DATE: November 16, 2022
TO: Potential Respondents
FROM: Carrie Stoeckert—Senior Construction Contract Coordinator
SUBJECT: Questions #1
RFCSP752-23-261209CS
UNT Advanced Air Mobility (UAAM) Test Center

This document is being issued to answer questions that have been submitted as follows:

T1.01

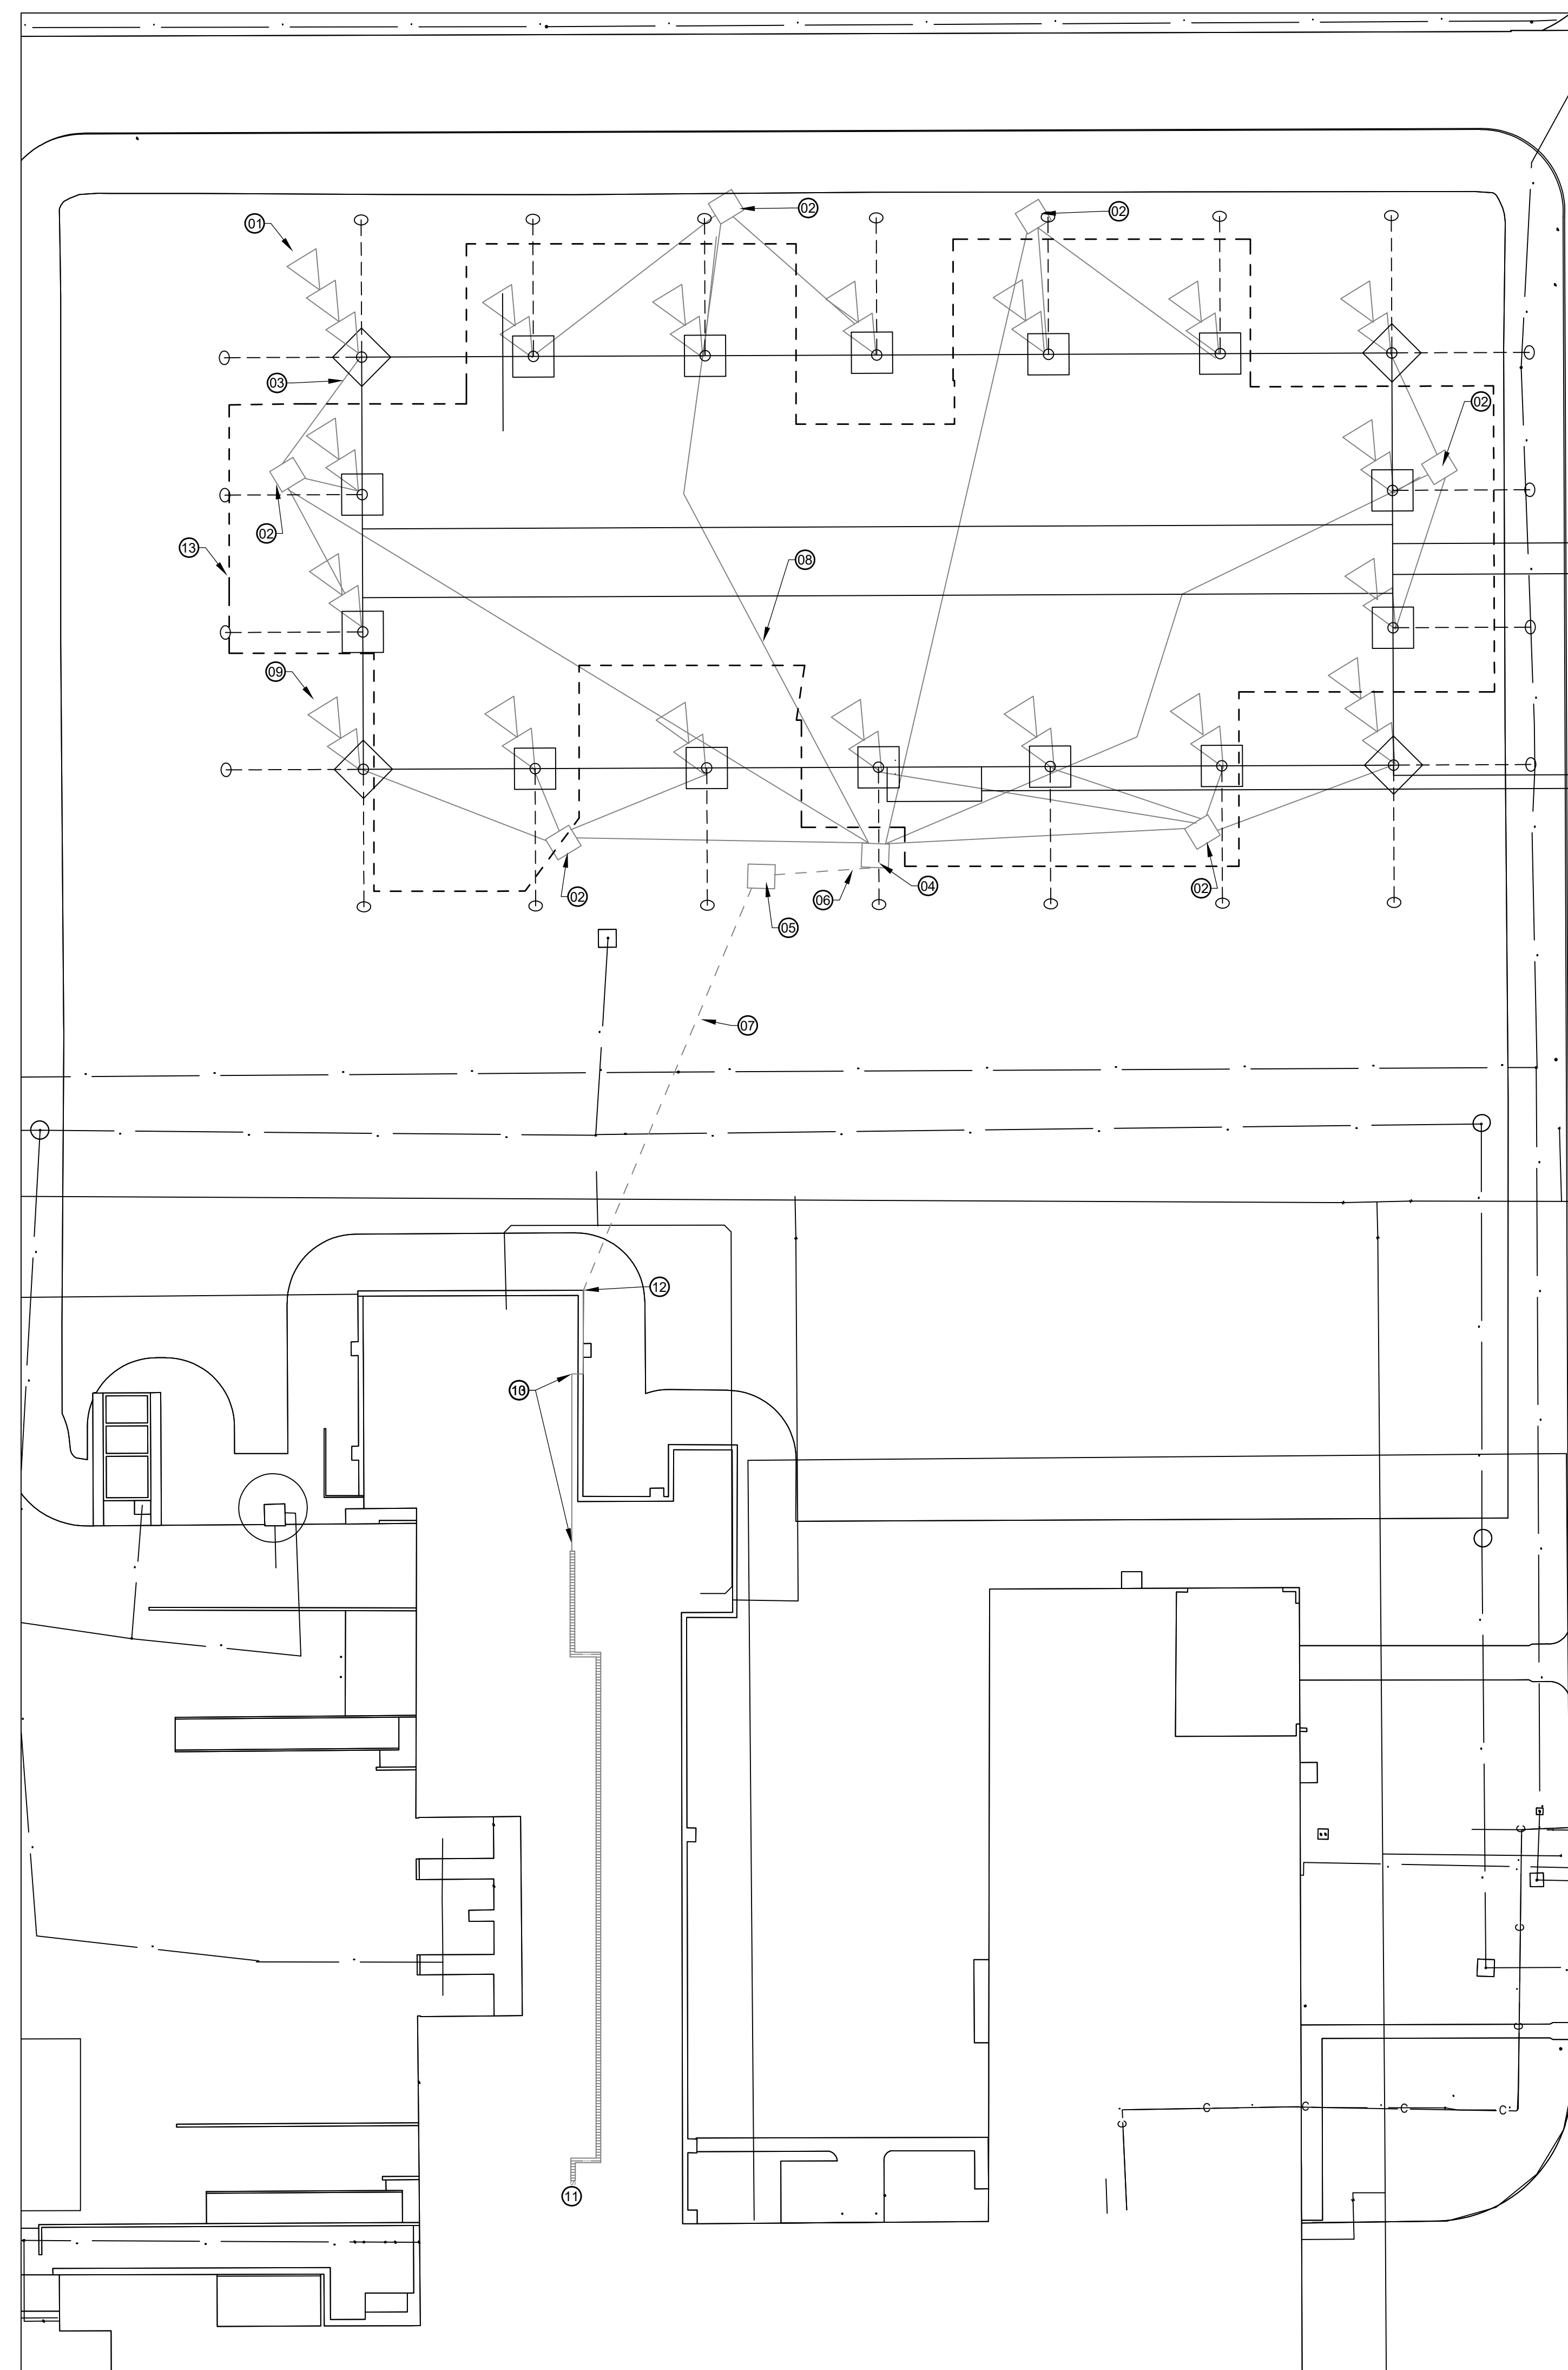
- a. **Electrical pad detail has been added to Sheet C9.00.**
5. The provided bid form indicates no alternates; however, the following alternates were listed on the documents; please clarify a. Sheet E2.01 - Add Alt #1: Provide (2) duplexes at pole mounted at 3ft and 10ft above ground. b. Sheet T1.01 - Add Alt #1: Provide (2) data drops at pole mounted at 10ft, 15ft above grade. Typical all poles with (2) drops. Sheet T1.01 - Add Alt #2: Provide (1) 6" C in lieu of (1) 4" C.

- a. **Revise bid form to include alternates attached.**
